SV TEMPLE PHASE III RAJAGOPURAM JSP24-17

Consideration at the request of Manyan Group for Preliminary Site Plan and Revised Phasing Plan approval. The subject property is located at 26233 Taft Road, situated south of Grand River Avenue and west of Taft Road (Section 16). The property is zoned RA (Residential Acreage). The applicant proposes to construct a 3,100 square foot Rajagopuram entry tower in front of the existing temple, enclose the stairwell and exterior second floor porch, as well as reorder the previously approved phases in order to construct the Rajagopuram prior to the cultural center.

PLANNING REVIEW

Second Revised Preliminary Site Plan

PHASING PLAN
SHEET 1 OF 2
JOB No 23-1016
SHEET C-4
SHEET 4 OF 14

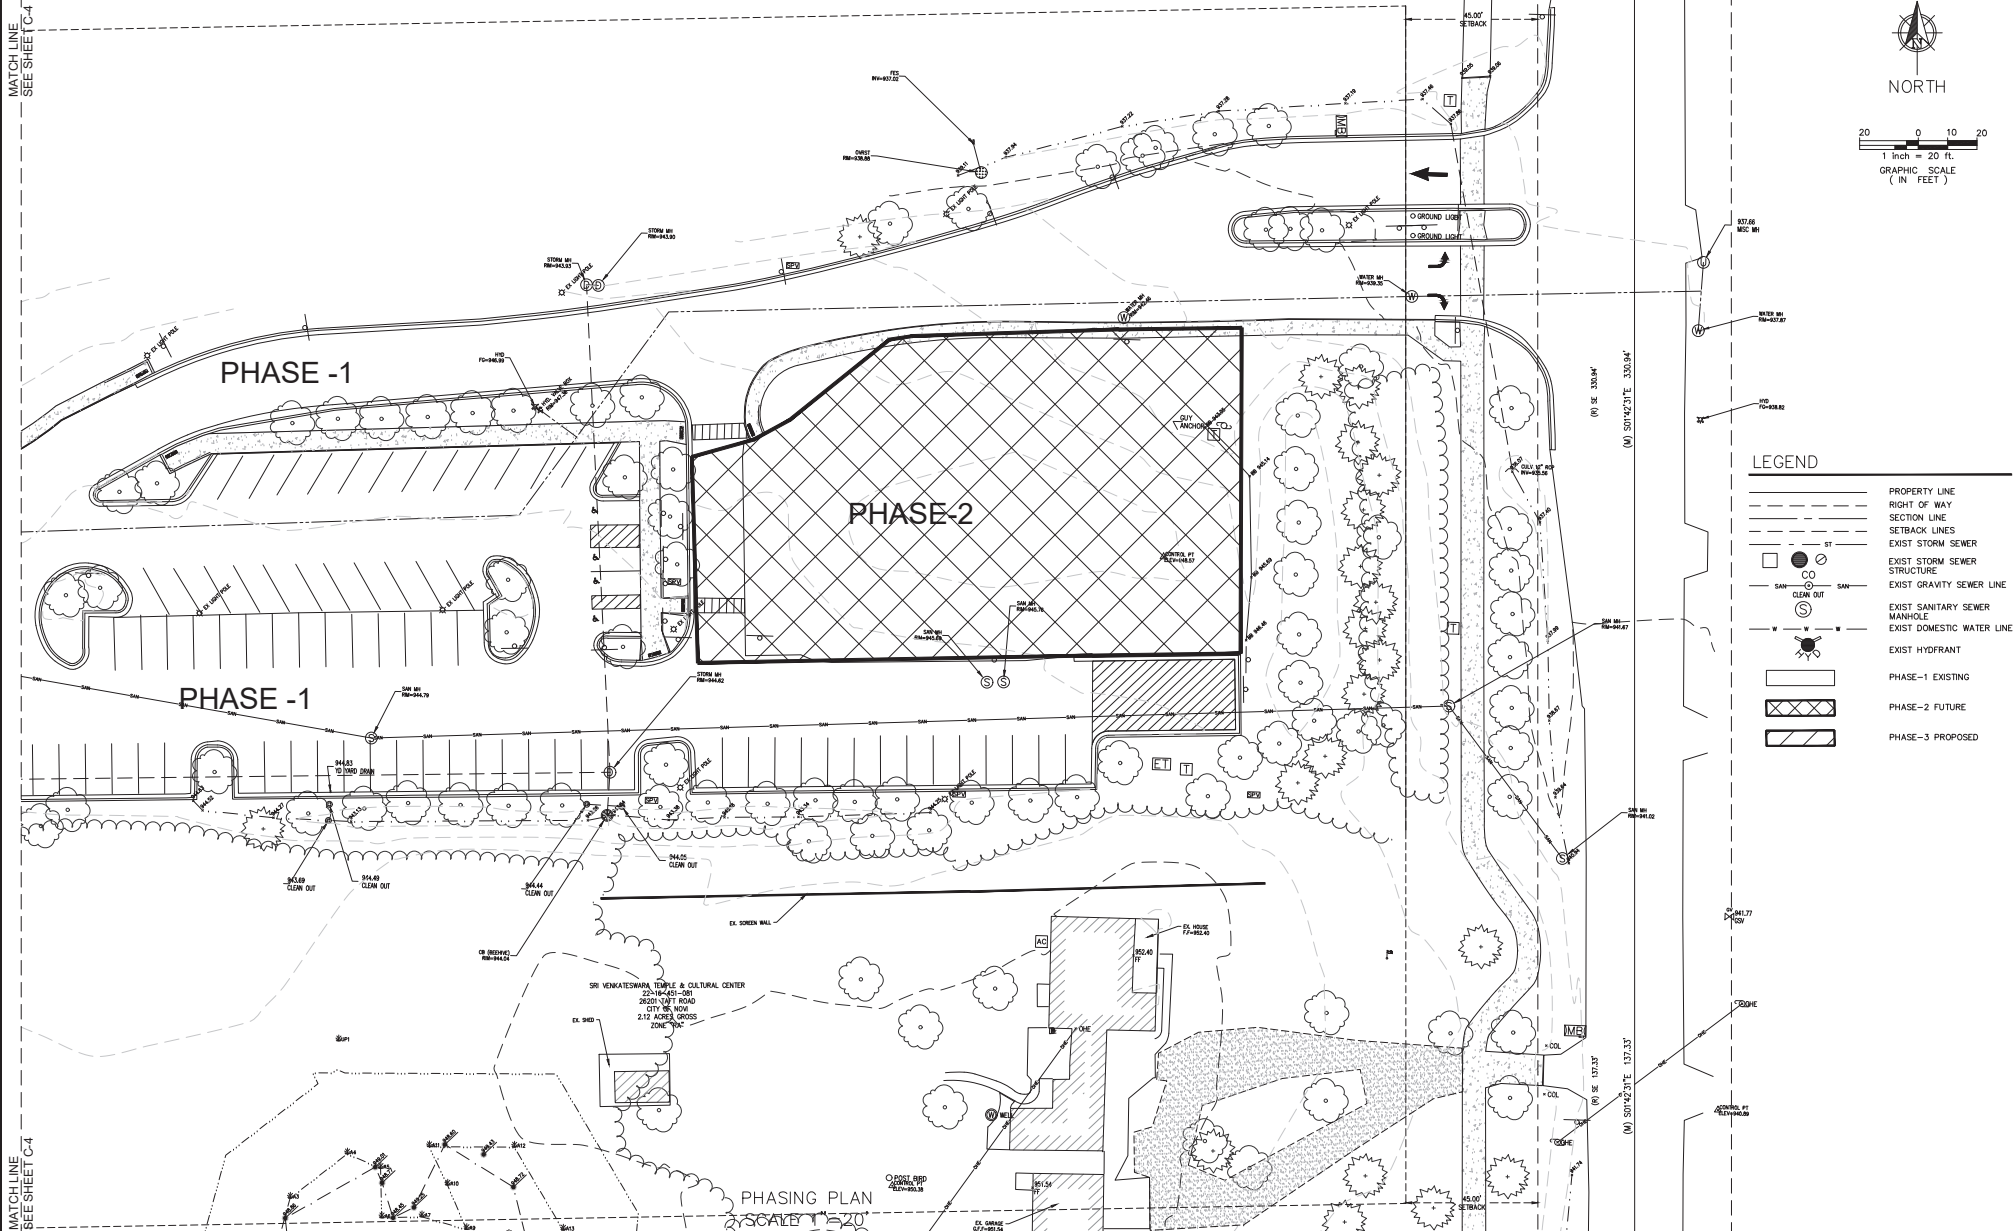
3. Phasing Plan Revisions (Section 6.1.B.vii.d): Reordering of phases requires approval from the Planning Commission. On the next submittal, please indicate that the proposed cultural center would be changed to Phase 3. Clearly differentiate phases not part of the project on plans with screening or boundary lines.

rPSP: Resolved - differentiation of the phases has been indicated on the plans.

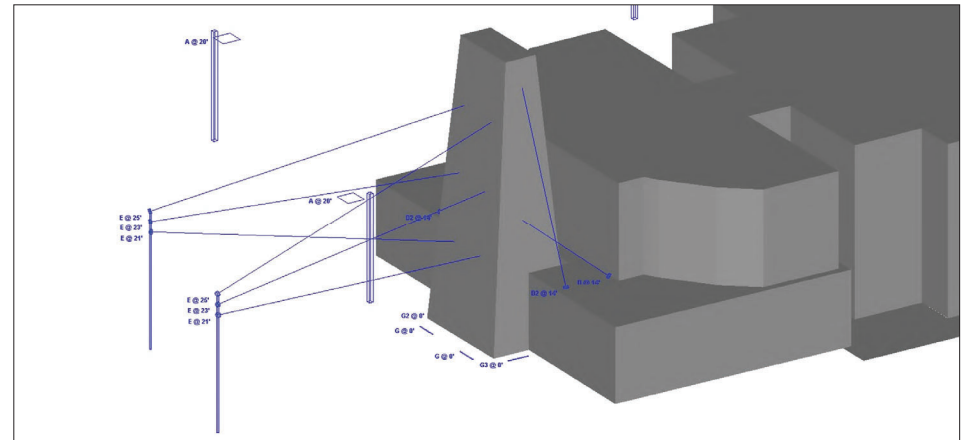
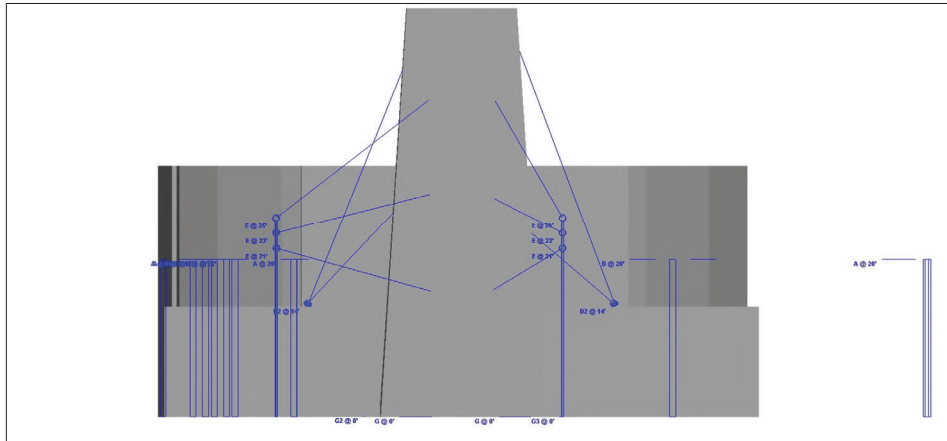
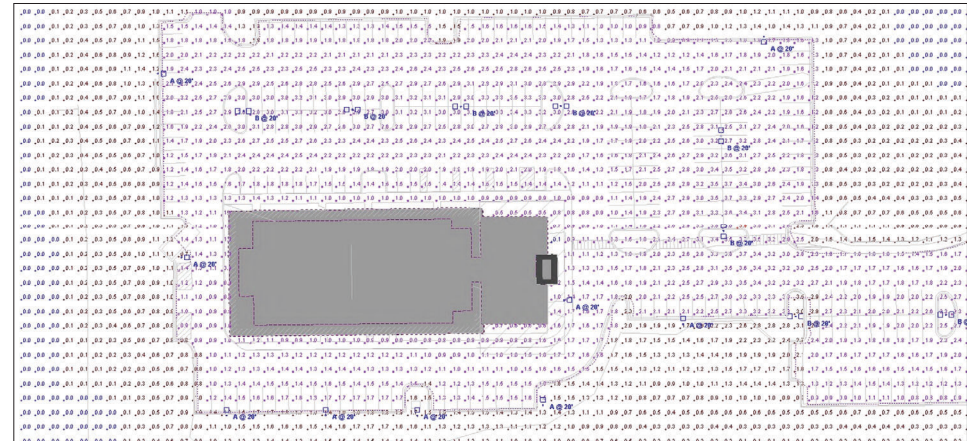
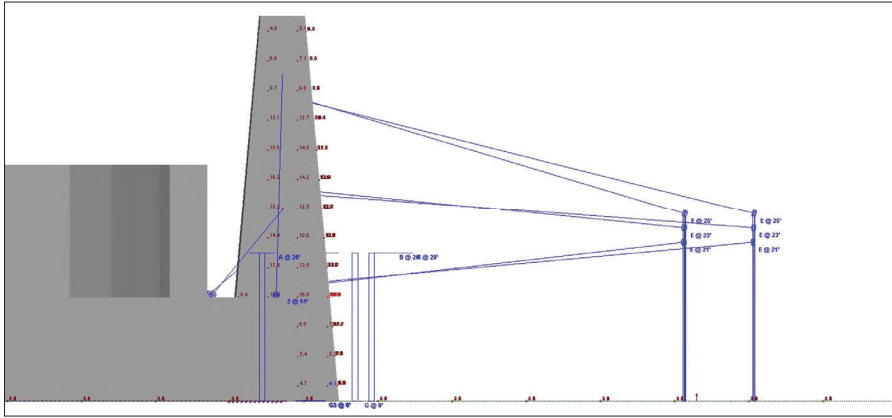
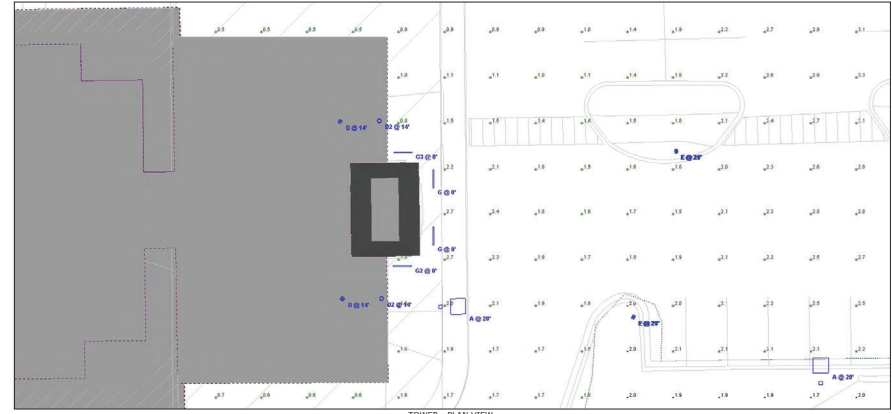
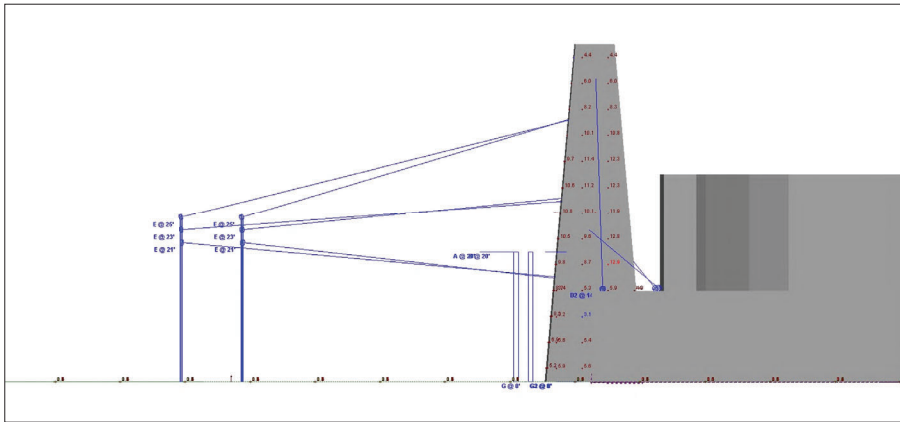
rPSP: The photometric plan indicates color changing pole and deck mounted LED lighting to be used to illuminate the Rajagopuram. Please provide lighting details as requested in the Façade review letter to demonstrate compliance with the ordinance.

rrPSP: Resolved: The applicant notes in their response that all items pertaining to color changing LED lighting have been removed in favor of a standard lighting approach and notes that the tower should always be lit white. The spec sheets have been updated to fixtures with white and static colors. The applicant indicates the fixture being specified is a 3000K standard white light. This will be made a condition of Planning Commission approval. Please refer to the Façade review for further information.

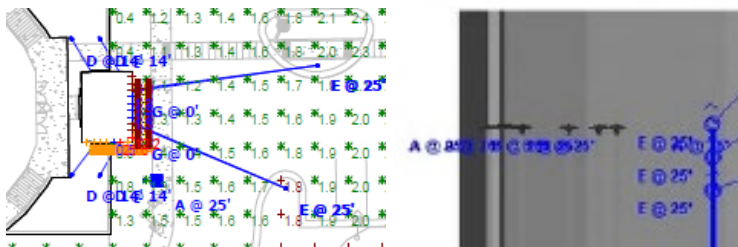
The 8.5:1 ave/min ratio for parking lot lighting and 7.9:1 ave/min ratio for the tower-south lighting exceed the required 4:1 standard. Please add north elevation photometric calculations on lighting sheets 1 and 3.

The applicant should revise the lighting plan to meet the ave/min calculation requirements and/or provide a justification in their response letter explaining why the uniformity requirement should not apply to the temple tower illumination. This should include a clear distinction between vertical architecture lighting and horizontal surface lighting, as well as an explanation of whether the tower lighting contributes measurable light to the horizontal plane. Consideration should also be given to providing separate calculations (e.g., with the tower lighting turned off) to isolate and evaluate the parking lot lighting independently.
